2000 Hyundai Sonata L4-2.4L

CV Joints - Shudder On Acceleration

Number: 01-40-018

Subject
1999-2000 SONATA SHUDDER OR VIBRATION
DURING ACCELERATION

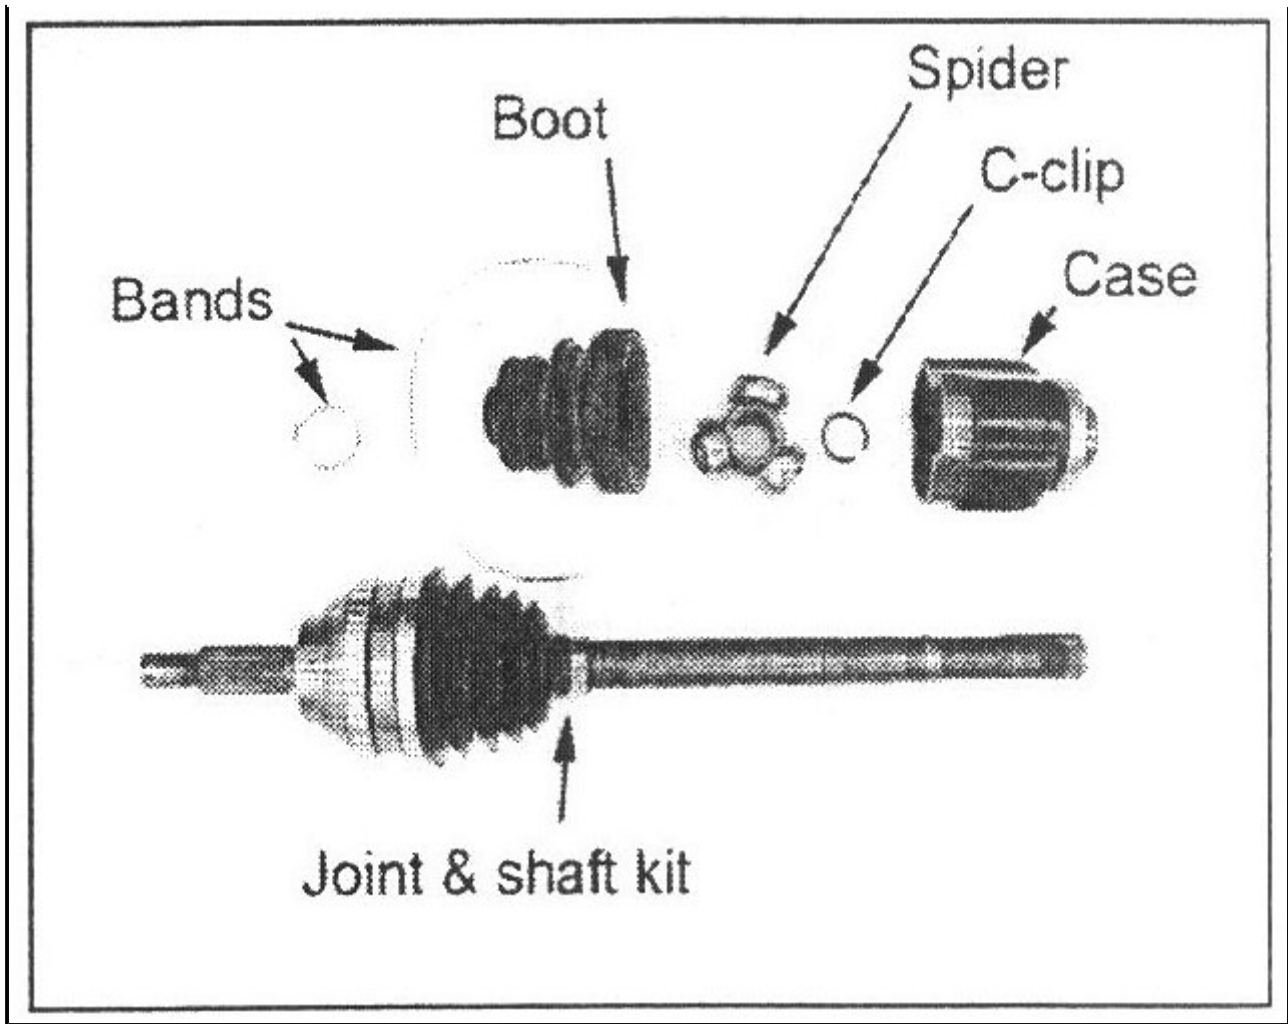
Some 1999-2000 Sonata vehicles produced prior to 4/12/00 may shudder or vibrate slightly during medium to full throttle acceleration.

To correct this condition, replace both CV joints on the left and right side driveshafts.

REPAIR INFORMATION:

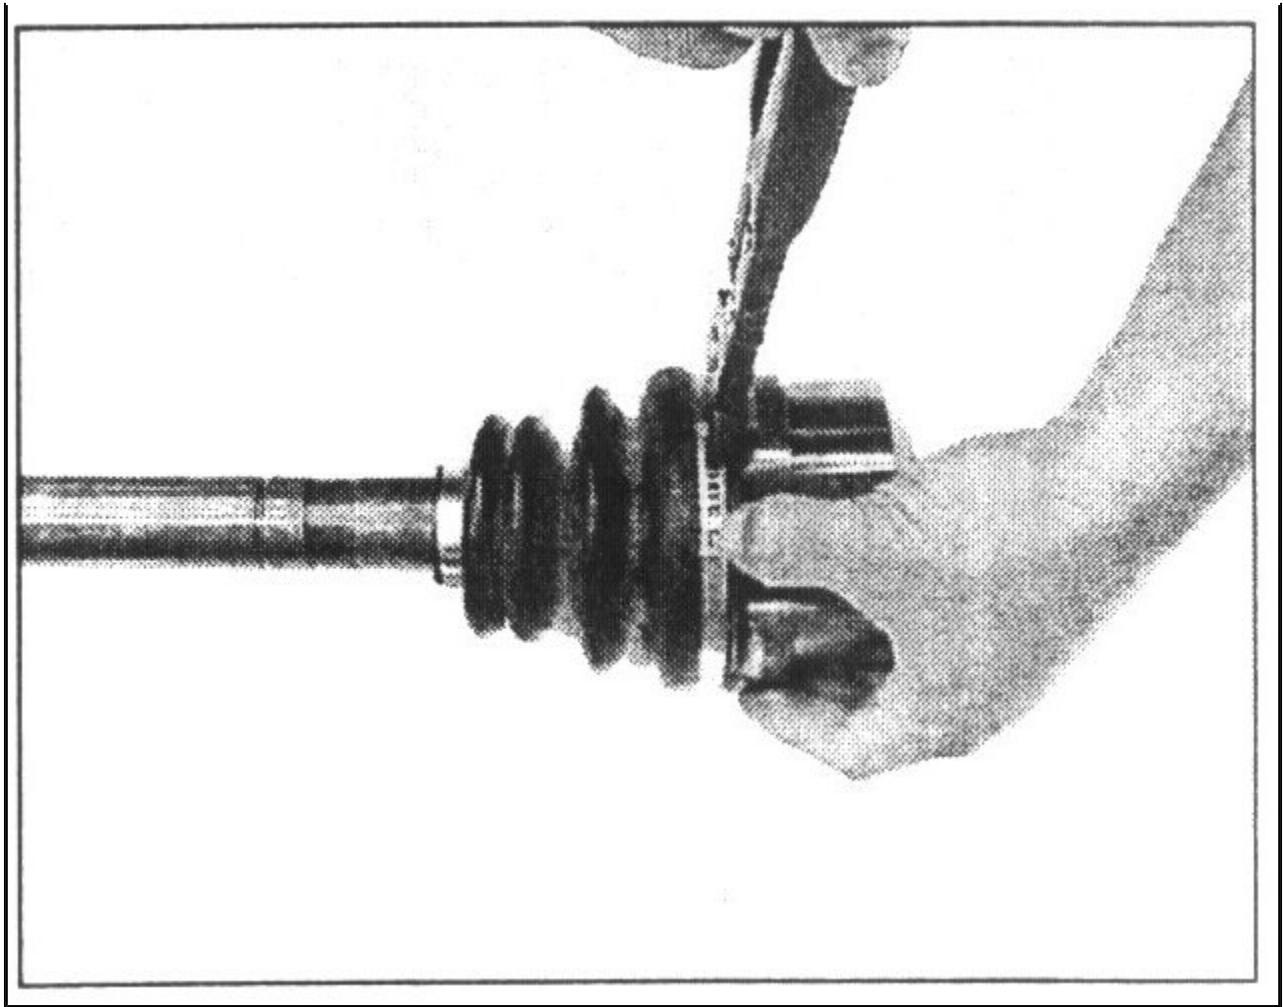
1. Remove the drive shaft according to the 1999 or 2000 Sonata Shop Manual, Page DS-8. Assemble the new driveshaft as shown in Steps 2-6.
2. Install the small band and boot on the joint and shaft kit.
3. Install the spider and the C-clip.
4. Add CV grease (supplied with the joint and shaft kit) to the [case](#) and boot.
5. Install the [case](#) to the spider.

6. Install the boot to the [case](#) and attach both bands on the boot, using CV joint pliers.
